# **Preliminary detailed assessment of best available techniques (BAT) for General Nuclear System Limited's UK HPR1000 design - AR03**

This report covers our Generic Design Assessment (GDA) of General Nuclear System Limited's (GNSL's) submission on best available techniques (BAT) for the United Kingdom Hualong Pressurised Water Reactor design (UK HPR1000) as required in Table 1, Items 2, 4 and 5 of our Process and Information Document (P&ID) (Environment Agency, 2016).

**Figure 3: Liquid effluent streams and LRWMS (GNSL, 2020b)**

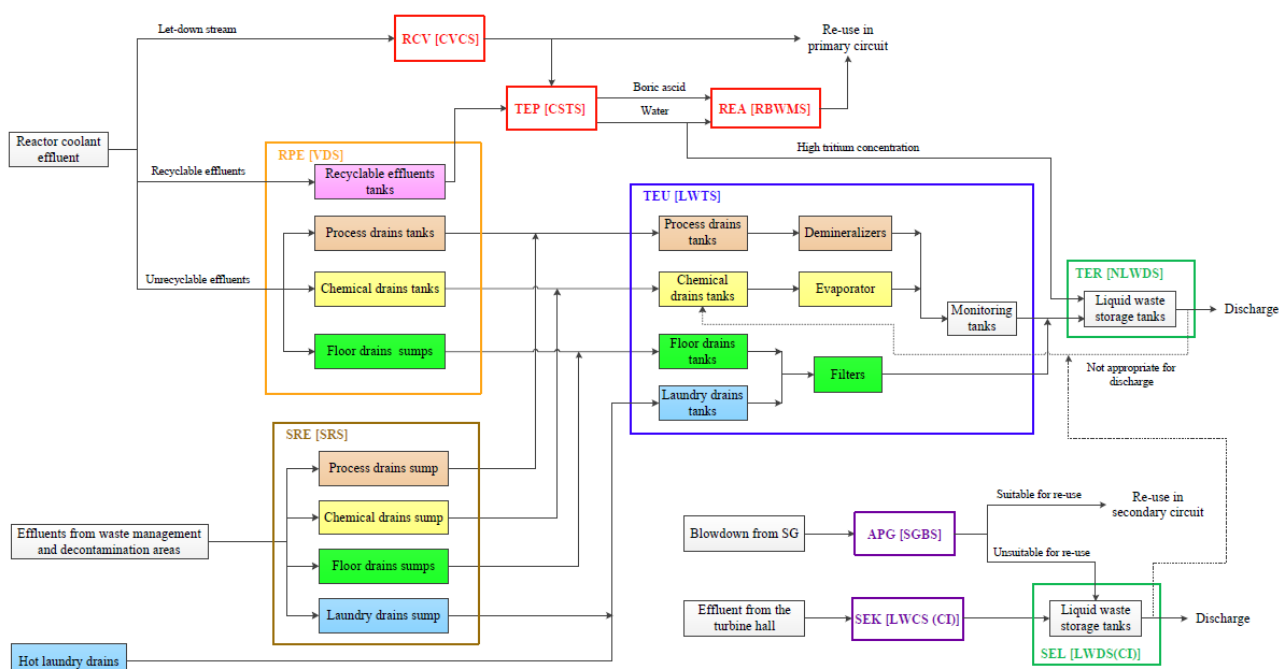
The techniques in the LRWMS include using filters, demineralisers and evaporators as shown in Figure 3 in section 2.8. The filters remove insoluble solid particles and fibres, the demineralisers remove soluble radionuclides, and the evaporators extract distillate and keep impurities in the concentrate. The demineralisers contain ion exchange resin and the regulators queried the validity of expected decontamination factors (DFs) and how the DFs are optimised (RQ-UKHPR1000-0725). The response to the RQ confirmed that the expected DFs are determined from OPEX and demonstrated that the abatement efficiency is optimised by considering factors, including resin volume, equipment design parameters and other measures to maximise the efficiency (such as monitoring and sampling, and pH and impurity control). A future operator will need to demonstrate that the selection of resin and resin change strategy used in demineralisers is optimised and can be demonstrated to be BAT. We have raised an Assessment Finding to this effect.

**Assessment Finding 5: A future operator shall demonstrate that the UK HPR1000 will be operated in a way that represents best available techniques for the selection and change strategy of demineraliser resins for liquid waste management systems.**
